Geri & Harold Sullivan
 5576 Wildwood Drive
 Rapid City, SD 57702-8813
 ghsullivan@rap.midco.net

REQUEST 2ND CURB CUT
 FOR RV PARKING.

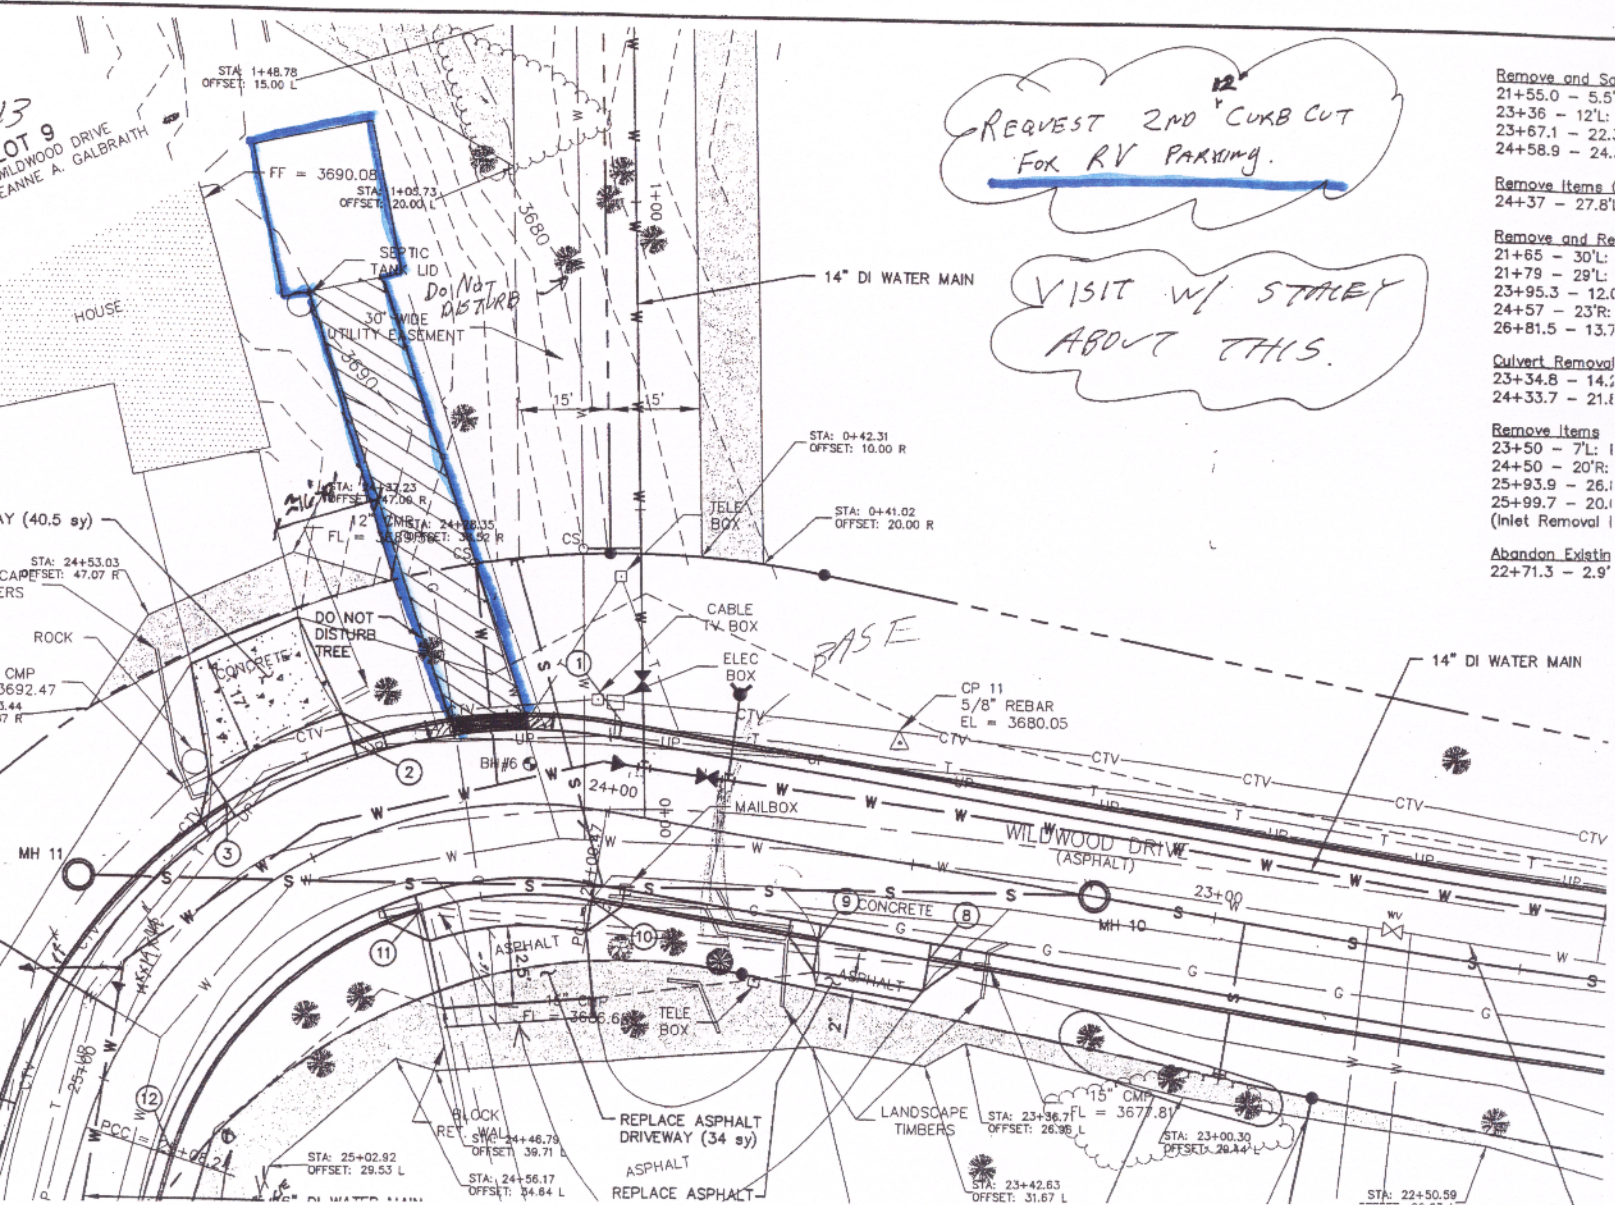
VISIT W/ STALEY
 ABOUT THIS.
